INTERNAL MEMORANDUM

Register Reference: SD22A/0099

Location: Site at Calmount Road and Ballymount Avenue, Ballymount Industrial Estate, Dublin 12
Applicant: Blackwin Limited
App. Type: Permission

The purpose of this memorandum is to advise the Development Management Section on the progress of the City Edge Project, to comment on the above proposal from the perspective of the Planning Delivery Team and, in turn, to inform the Chief Executive's Report on the planning application.

Figure 1: Medium to Long Term Road Proposal through application site – South Dublin County Council Development Plan 2016 - 2022

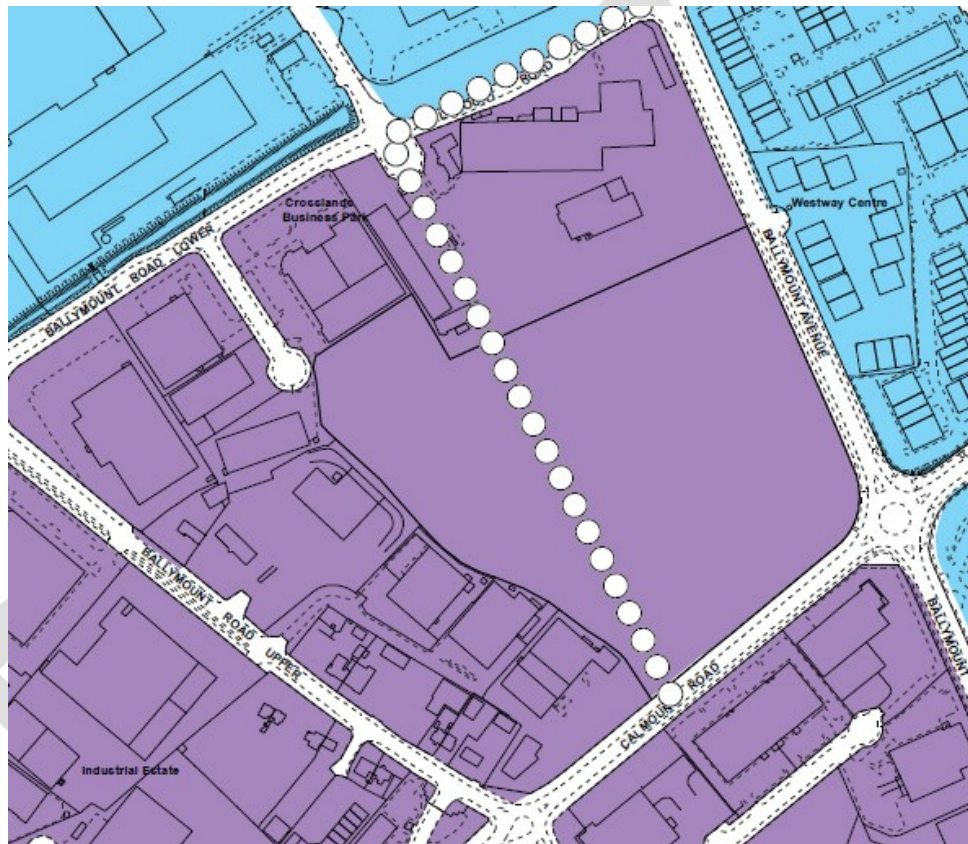
The Planning Delivery Team advise that the subject Roads Objective is of potential importance from the perspective of helping to create a permeable network of streets and urban blocks that links Calmount Road with Ballymount Road Lower while aligning with the Merrywell Industrial Estate Road to the north of the application site.

Figure 3: Extract from Proposed Layout Plan indicating road to be taken in charge.

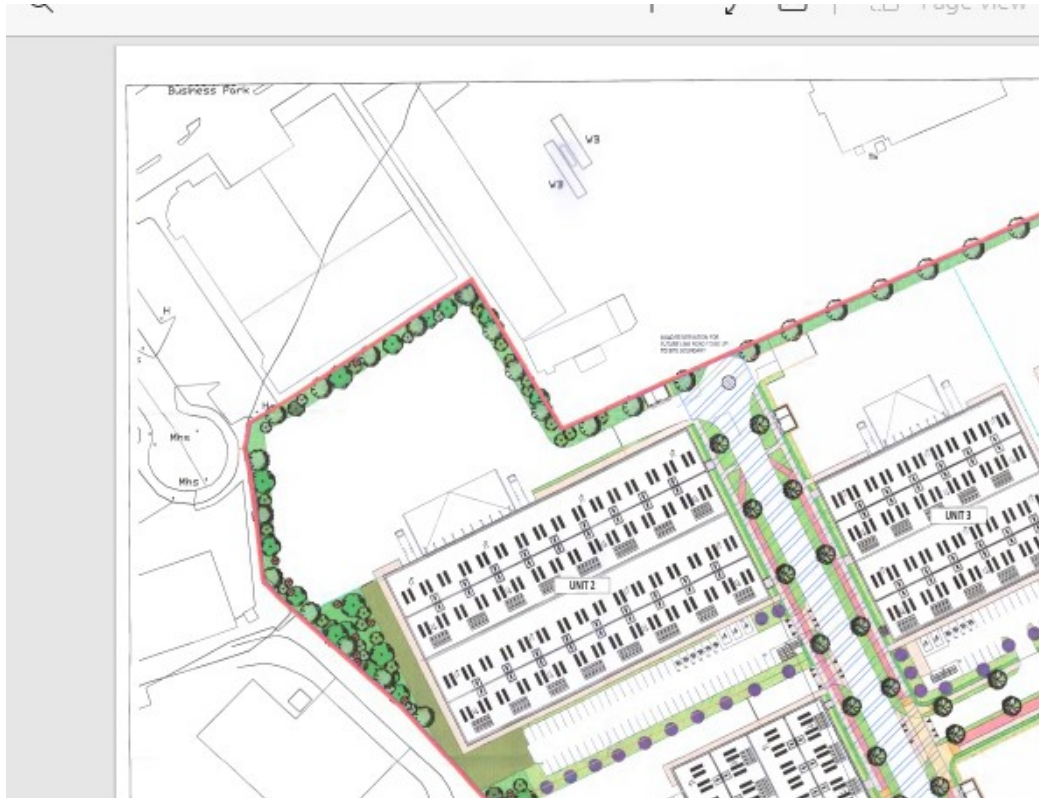
The development proposal responds to this roads objective through the incorporation of a road proposal through the application site, which the applicant suggests will be taken in charge by the local authority. The proposed road would be accessed via a splayed entrance off Calmount Road at the southern boundary of the application site and would terminate at its northern boundary in the form of a “mini round about”.

The proposed road would have a carriageway width of approx. 9 metres and would be flanked by planted verges (2 metres wide), footpaths (1.75 - 1.8 metres wide) and off-road cycle lanes (1.5 – 1.75 metres wide).

Using the Design Manual for Urban Roads and Streets (DMURS, 2019) as a guide, the suggested carriageway width would exceed that recommended for the highest level street (Arterial – max 7 metres). No design rationale has been submitted, however, for the proposed through road.

Furthermore, the appropriate hierarchical positioning, width(s), alignment and connection point with Ballymount Road Lower for the County Development Plan Roads Objective to which the subject through road proposal relates, is yet to be fully investigated and determined by the planning authority.

Within this context, the applicant should be requested to submit a Street Design Statement on the proposed through road by way of further information request. Such a design statement should accord with the requirements of Section 5.2.2 DMURS (2019) and should include details that demonstrate the process that was undertaken to inform the design of the proposed through road and its outcome including:

In order to minimise the potential for the proposed development to prejudice the completion of the County Development roads objective through the application site in terms of realising a connection with Ballymount Road Lower, the applicant should also be requested to demonstrate how the proposed development would accommodate optional alignments/connections by way of further information. Such a further information request should make reference to the potential to link with Ballymount Road Lower via the existing turning circle and industrial estate road directly on the north-west boundary of the application site. This option could be kept open by way of relocating the HGV loading for Unit 2 out of the path of a potential route towards the existing turning circle and by removing any proposed gateway controls.

Figure 6: Extract NTA's Greater Dublin Area Cycle Network Plan (2013)

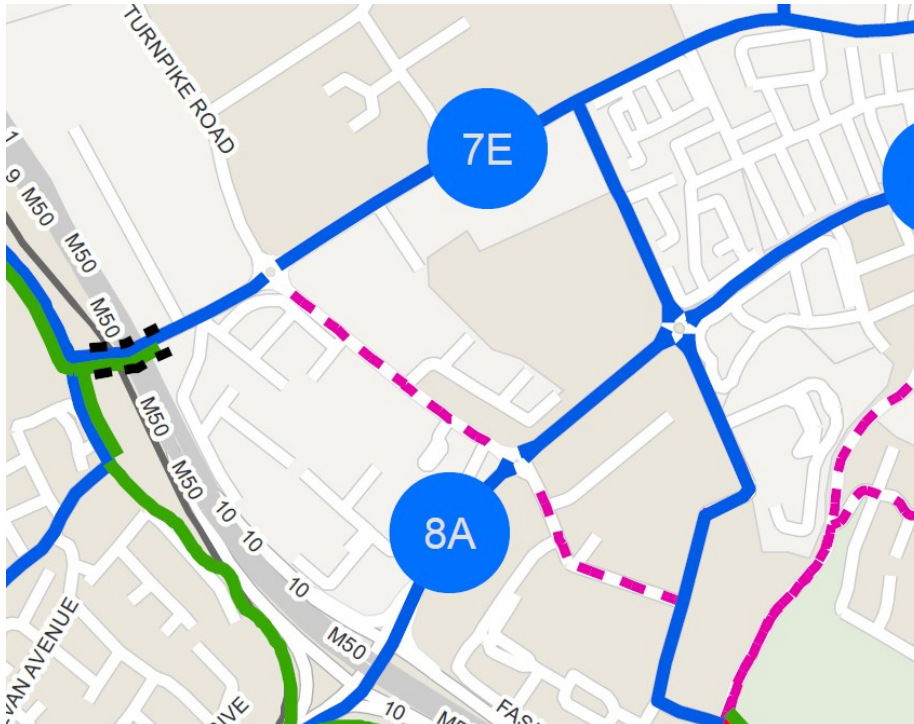
It is noted that an off-road cycle track and footpath already exists along the eastern/Ballymount of the site, however, no such facilities exist along southern/Calmount Road Boundary, which comprises a grass verge. The proposed development responds to this with the inclusion of a two-way off-road cycle track along the southern/Compound Road Boundary of the application site together with a footpath and planted verge to replace the grass verge. The proposed two-way cycle lane would continue around the southeast corner of the site and tie in with the existing single way cycle lane on Ballymount Avenue. The proposed cycle track coincides with a letter of consent and map from SDCC relating to a proposed watermain connection on Council Owned lands along the southern boundary of the site. A landscaping section indicated that the proposed two-way cycle track would measure 2.5 metres in width, which appears to comply with the NTA'S National Cycle Manual in terms of appropriate cycle lane/track widths.

As mentioned above, there is potential conflict between a section of the applicant's proposed two way cycle track and shared surface at the south -east corner of the application site and the roundabout conversion under the *NTA's Greenhills to City Centre Core Bus Corridor Preferred Route* (November 2020). This issue has already been dealt with in this report above.
